APPLICATION NO.	FILING DATE	FIRST NAMED INVENTOR	ATTORNEY DOCKET NO.	CONFIRMATION NO.	
10/814,246	04/01/2004	Takahiro Okuno	251363US2	6970	
22850	7590 01/10/2006		EXAMINER		
OBLON, SPIVAK, MCCLELLAND, MAIER & NEUSTADT, P.C. 1940 DUKE STREET ALEXANDRIA, VA 22314			ARENA, ANDREW OWENS		
			ART UNIT	PAPER NUMBER	
			2811		
				DATE MAILED: 01/10/2006

Application No.	Applicant(s)				
	10/814,246	OKUNO ET AL.				
Office Action Summary	Examiner	Art Unit				
	Andrew O. Arena	2811				
The MAILING DATE of this communication app Period for Reply	ears on the cover sheet with the c	orrespondence address				
A SHORTENED STATUTORY PERIOD FOR REPLY WHICHEVER IS LONGER, FROM THE MAILING DA - Extensions of time may be available under the provisions of 37 CFR 1.13 after SIX (6) MONTHS from the mailing date of this communication. - If NO period for reply is specified above, the maximum statutory period w - Failure to reply within the set or extended period for reply will, by statute, Any reply received by the Office later than three months after the mailing earned patent term adjustment. See 37 CFR 1.704(b).	ATE OF THIS COMMUNICATION 36(a). In no event, however, may a reply be tim will apply and wil

FIG. 13

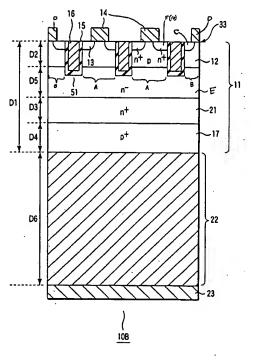
4. Regarding claims 1 and 8, Tanaka discloses (Fig 13) a semiconductor device comprising:

a drift layer (E) of a first conductivity type;

a collector layer (17) of a second conductivity type located on the drift layer;

a collector electrode (22,23) located on the collector layer;

a base layer (12) of the second conductivity type located in a region isolated from the collector layer on the drift layer;

a plurality of trenches (51) formed at certain intervals to extend from the top surface of the base layer into the drift layer and thereby divide the base layer to main cell regions (A) and dummy cell regions (B);

a first emitter layer (F, 13) of the first conductivity type selectively formed in the surface layer of the base layer in each main cell region to extend along adjacent one of the trenches;

gate electrodes (16) formed in the trenches sandwiching each main cell region among said plurality of trenches via a gate insulating film (15);

an emitter electrode (14) located over the base layer and the first emitter layer in each main cell region; and

a second emitter layer (C) of the first conductivity type selectively formed so as to be scattered in the surface layer of the base layer in each dummy region and having a surface area smaller than that of the first emitter layer (Note that Fig. 13 clearly shows second emitter layer (C) smaller than first emitter (F). With respect to this comparison,

drawings may not be interpreted as providing exact dimensions, but may be interpreted to indicate relative sizes).

- 12. Regarding claims 5 and 13, Tanaka discloses (Fig 13) the semiconductor devices having the second emitter layer (D) formed as patterns in contact with the trenches (51) opposed to each other via the base layer in each dummy cell region.

- 17. Examiner does not concur that "Tanaka fails to disclose or obviate" the common fundamental feature of Claims 1 and 8 "that a base layer of the second conductivity type is divided into main cell regions and dummy cell regions." Nothing in the claims and no submitted evidence precludes the labeling of main (A) and dummy (B) cell regions in Fig 13 of Tanaka. The claims fail to structurally distinguish over the cited art.
